Landscape Referral Response

Application Number:	DA2022/1057
Date:	25/08/2022
Responsible Officer:	Michael French
Land to be developed (Address):	Lot 12 DP 238220 , 8 Chatham Close BELROSE NSW 2085

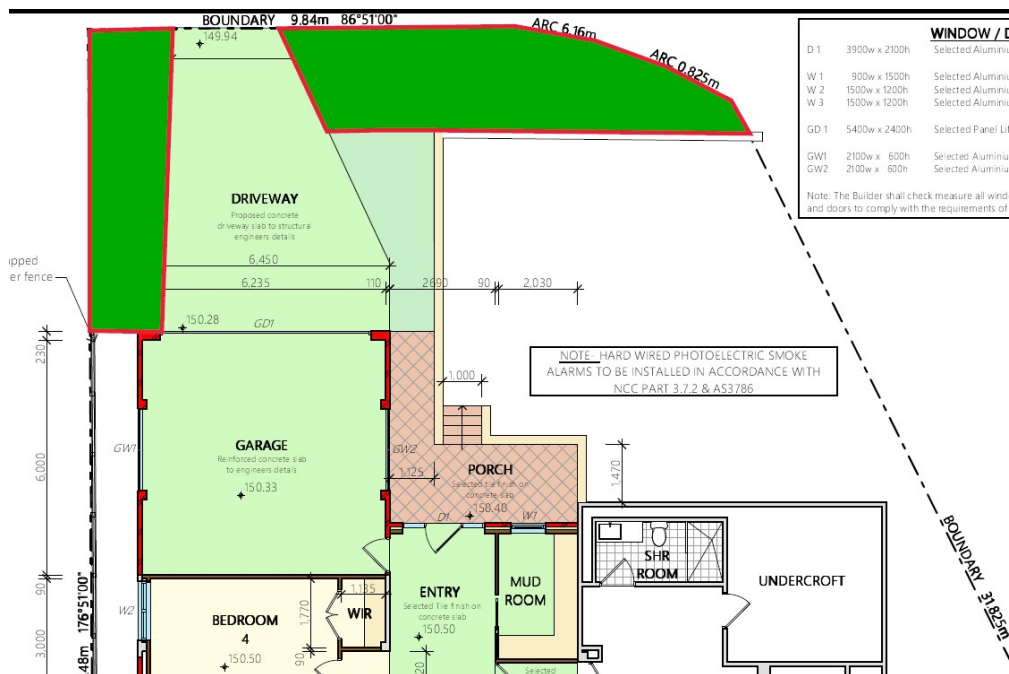
The application proposes to remove two native trees and mature landscape from the front setback which currently help to satisfy DCP control D1. The two trees, proposed to be removed, are the only trees located within the property boundary and no replacement trees are proposed. Landscape Referral raises concerns that the rooftop garden, above the proposed garage, will not have sufficient soil depth to support planting. The perimeter raised garden beds can be supported (if shrub planting is proposed and a minimum 600mm soil depth is achieved); however, the small area of paving and glass balustrade shall be removed and the raised garden bed shall continue along the northern edge. The perimeter raised garden beds shall also have a minimum internal width of 600mm. The lower planting area (of the roof top garden), around the 'floating' pavement, does not appear to have sufficient soil depth, and

more information is required. A minimum 600mm soil depth must be provided for shrubs and 300mm soil depth for native grasses and groundcovers.

Based on lack of information regarding landscape design, and the departure from the DCP controls D1 and E1, Landscape Referral are unable to support the application at this stage. More information is required in the form of a Landscape Plan which shall propose:

- two replacement trees (species, location and pot sizes) to achieve a minimum 6m height at maturity and be selected from Northern Beaches Council's Native Plant Species Guide - Frenchs Forest Ward, or Council's Tree guide,
- the proposed planting for all front setback garden areas (showing species, location quantities and pot sizes). Mass planted garden beds shall be at minimum in the areas shown in green below,

- the proposed planting for the rooftop garden (showing species, location, quantities and pot sizes) and more information regarding soil depths.
